**NOTICE OF DECISION TO CONSENT TO CHANGE TO PROPOSAL DURING
ASSESSMENT**

Arrowsmith North Silica Sand Project
Assessment No. 2291

STATEMENT OF REASONS

Figure 1: Revised Development Envelope and Disturbance Footprint

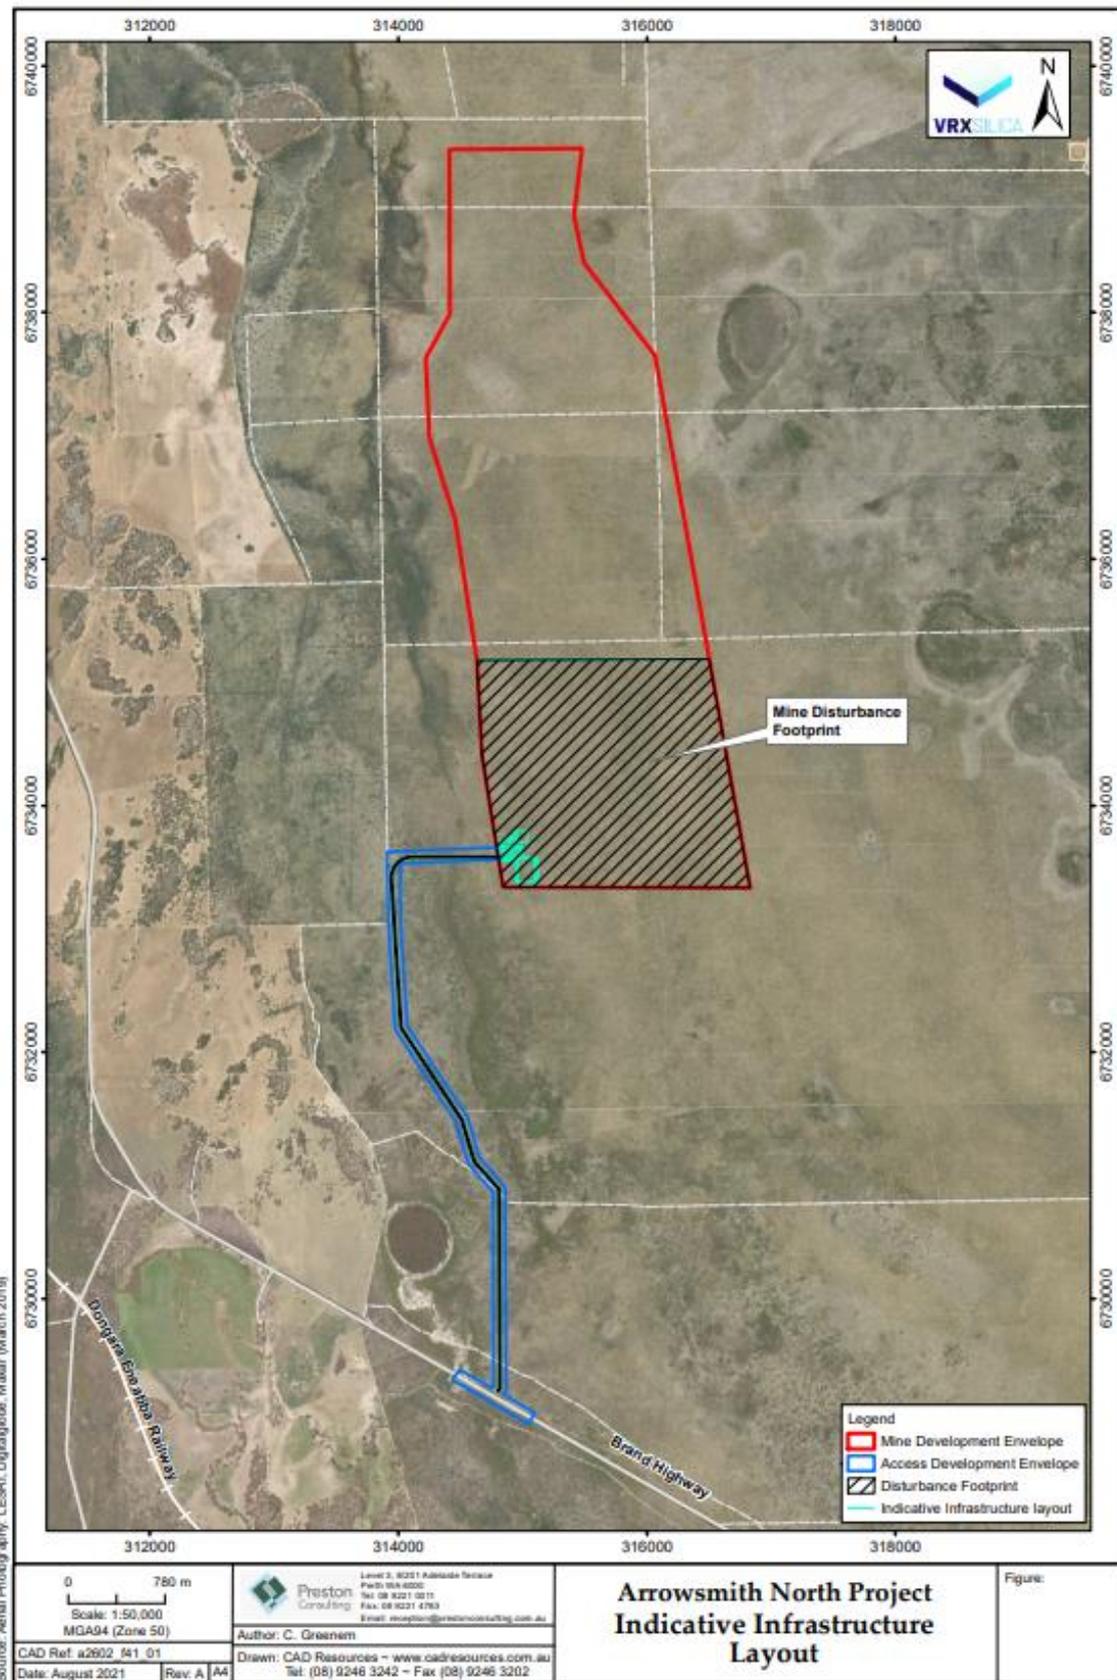
- Relocation of the silica sand processing plant from the Access and Processing Development Envelope to within the Mine Development Envelope.
- Removal of the train loadout facilities.
- Removal of the solar farm.
- A reduction in the extent of the Access and Processing Development Envelope from 447 hectares (ha) to 61 ha and renaming it the Access Development Envelope.
- An overall reduction in the extent of clearing from 412.2 ha to 366.5 ha.

See Figure 1 and Schedule 1 attached.

Element	Current proposed extent	Proposed change to extent
<i>Physical Elements</i>		
Mine Development Envelope	Clearing of no more than 360 ha within the 1,025 ha Mine Development Envelope.	Clearing of no more than 360 ha within the 1,025 ha Mine Development Envelope. Relocation of the Processing Plant from the Access and Processing Development Envelope to within the southwest corner of the Mine Development Envelope.
Access and Processing Development Envelope	Clearing of no more than 52.2 ha, of which no more than 16.2 ha is native vegetation, within the 447 ha Access and Processing Development Envelope.	Clearing of no more than 6.5 ha of native vegetation within the 61 ha Access Development Envelope. Relocation of the Processing Plant from the Access and Processing Development Envelope to within the southwest corner of the Mine Development Envelope.
Train Loadout Facilities*	The original Proposal included a train loadout that would be located adjacent	Removal of train loadout facilities from the Proposal. Train loadout is no longer part

to the Processing Plant stockpiles.	of the Proposal, product will instead be hauled off-site using trucks.
Solar Farm*	The original Proposal included a solar farm that would be constructed on an area of cleared land within the western option of the Access and Processing Development Envelope.	Removal of the solar farm from the Proposal. Landholder negotiations for a suitable site are unlikely to be completed prior to assessment.
Operational Elements		
Mining and Vegetation Direct Transfer (VDT)	Topsoil and vegetation is to be transferred to rehabilitation areas via VDT method. The total of all cleared areas within the Mine Development Envelope is to be no more than 10 ha at any time (i.e. excluding rehabilitation areas).	No change proposed.
Groundwater Abstraction	Abstraction of up to 0.9 GL per annum from the Yarragadee aquifer.	No change proposed.

1. The EPA considers that the change is unlikely to significantly increase any impact that the proposal may have on the environment. The proponent may change the proposal as provided for in this notice.
